RIVER FOREST ZONING BOARD OF APPEALS MEETING AGENDA

SUBJECT: Appeal of the decision of the Zoning Administrator – 558 Lathrop Avenue

OLSHESKY RESIDENCE
NEW SINGLE-FAMILY RESIDENCE

Re: Appeal of the Zoning Administrator's Interpretation of the Zoning Ordinance regarding 558 Lathrop Avenue

BASEMENT & FIRST FLOOR PLANS

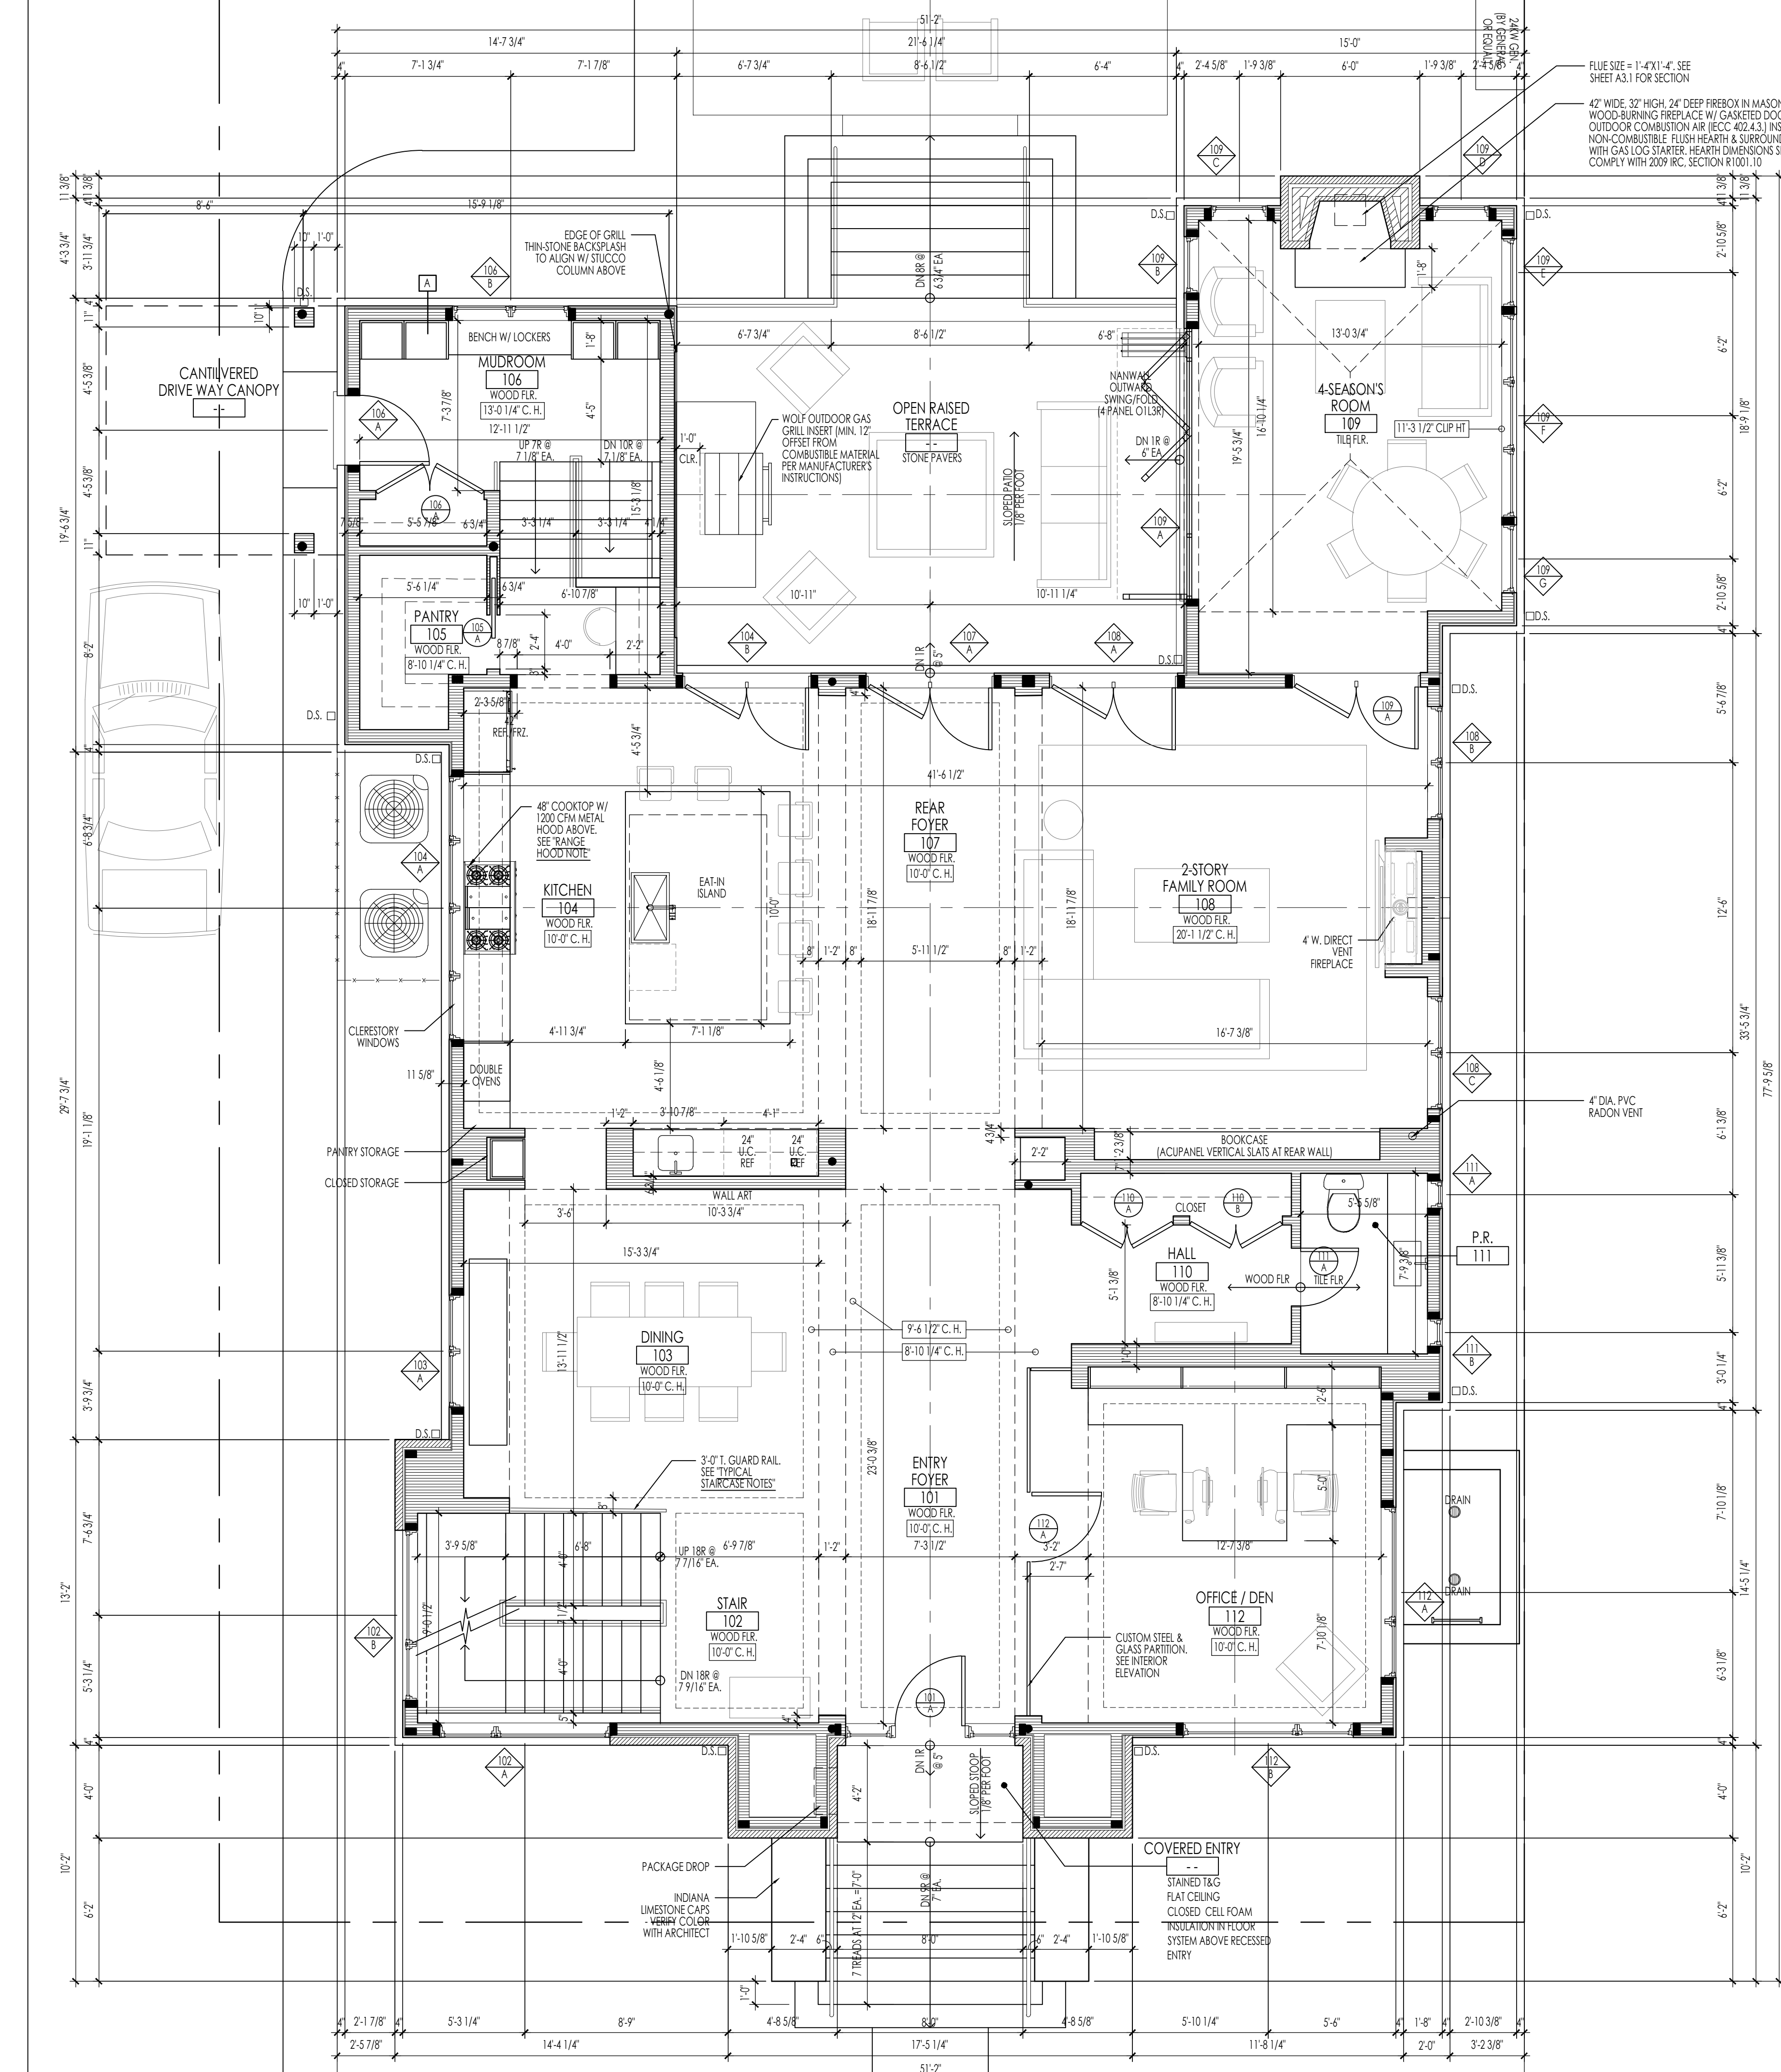
On the submitted drawings for the proposed house, the designer has chosen to set the elevation of the First Floor to be 4'-8" above the level of the ground directly adjacent to the building, rather than relating the floor to the elevation at the public walk, which is defined by the ordinance as "Grade". This relationship is shown on the Building Elevations on sheet A2.0, the Building Sections on sheet A3.0, and the Wall Section 1/A3.1. The level of the ground directly adjacent to the building is noted on the drawings to be 22 inches higher than the elevation at the public walk. Therefore, the First Floor is approximately 6'-7" above the elevation at the public walk, rather than the limit of 4'-9" set in the definition for Floor Area.

The definition does not prohibit the elevation of the First Floor from exceeding 4'-9" above the public walk, but it does require that when that elevation is exceeded that the area of the basement floor level be included in the calculation of the floor area ratio. Presently, the calculation of the Floor Area ratio for the proposed house, counting only the First and Second Floor, is 0.377. Adding the area of the Basement to the calculation will push the FAR substantially over the limit of 0.40, (probably close to 0.60).

EXTERIOR ELEVATIONS

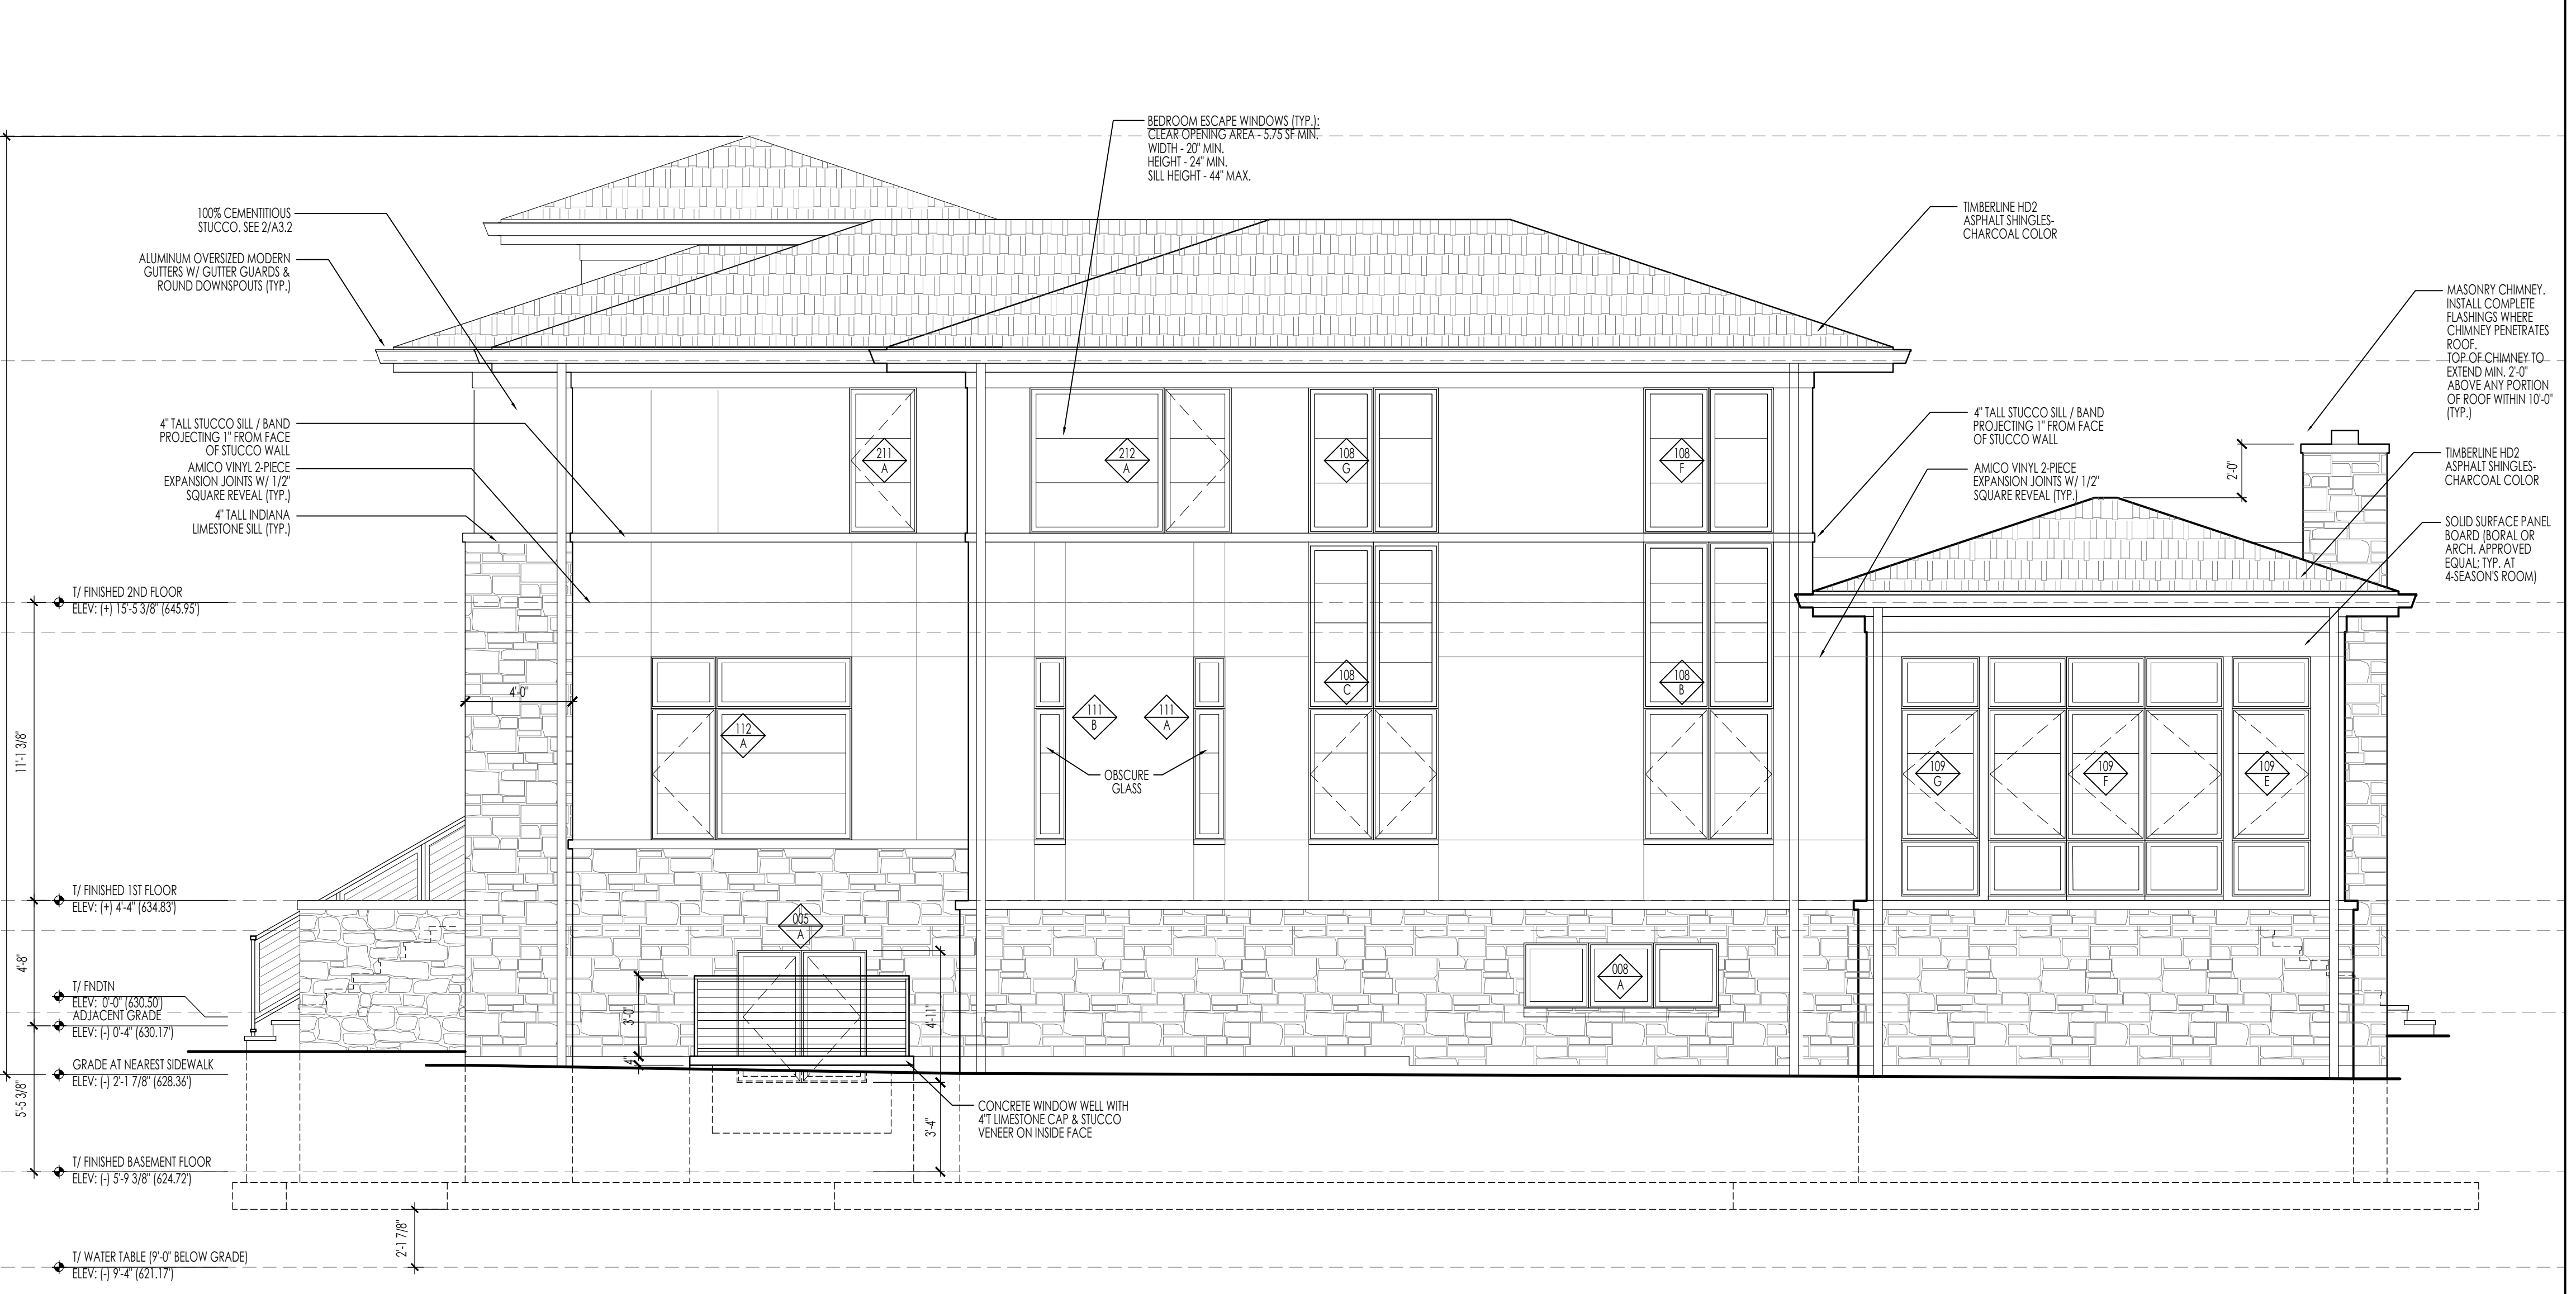
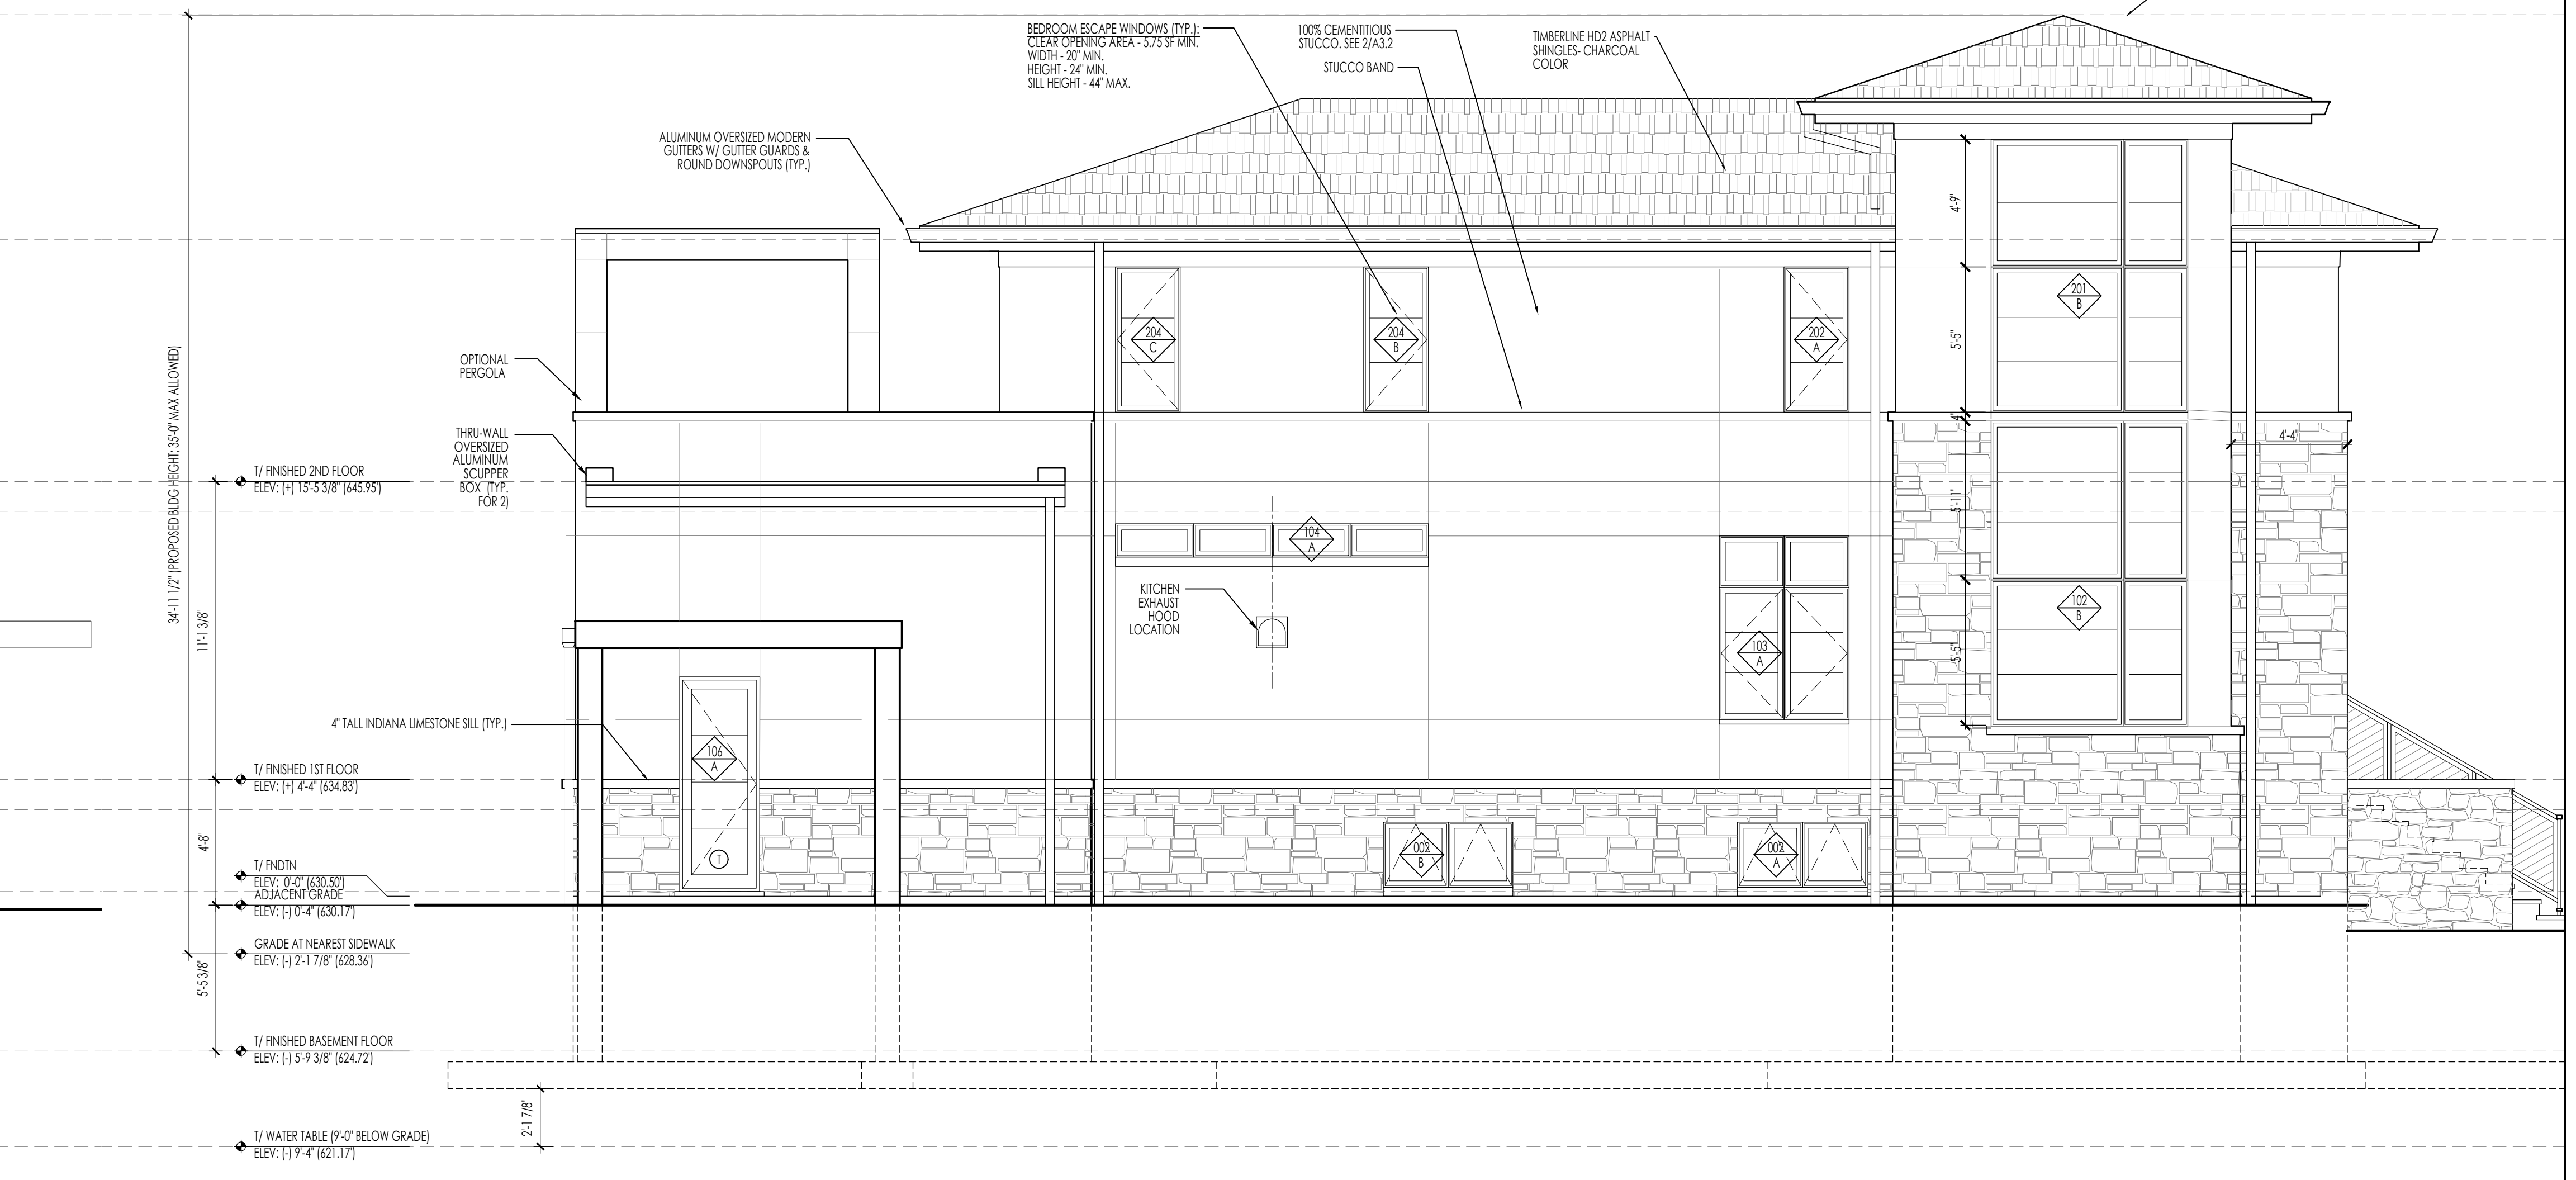
It should also be observed that the Building Elevations and Building Sections correctly relate the maximum Building Height to Grade, the elevation at the public walk.
